2011 Change Proposals - New Allowances (4 Items) Posted by joepaluch - 27 Oct 2010 06:04

These are **PROPOSED** Changes only based on driver and director suggestions. Please comment below. These are prposed NEW allowances to the 944 spec rule set.

2011-4.) Lexan rear Qtr windows

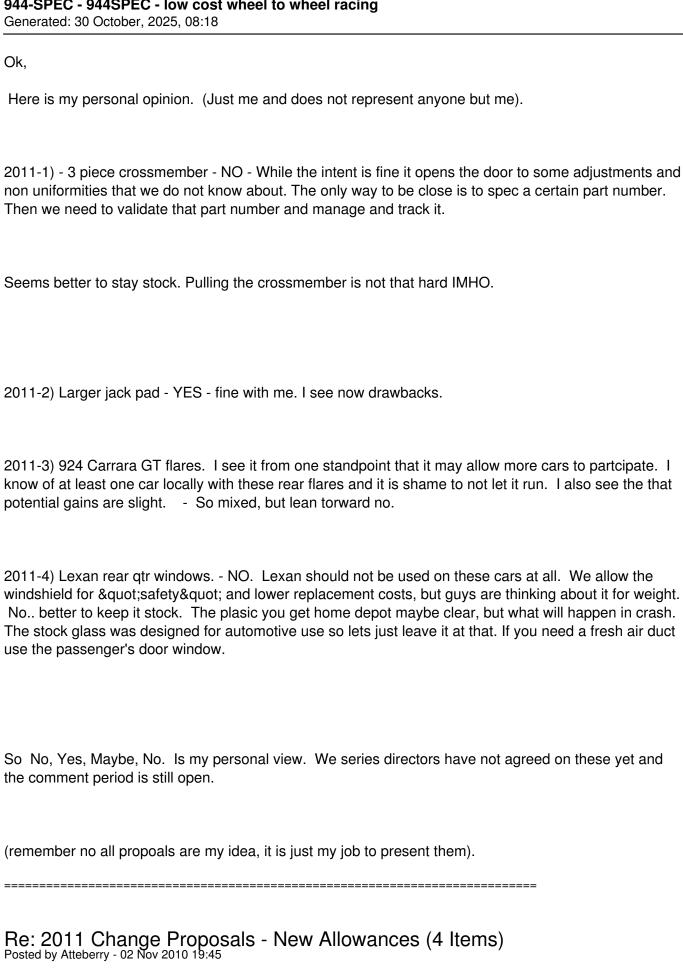
Proposal: Allow rear replacement of glass gtr windows with lexan and to allow air ducting to be installed in these lexan windows. No changes to rear hatch.

Justification: Makes it a nice clean way to provide fresh air ducting.
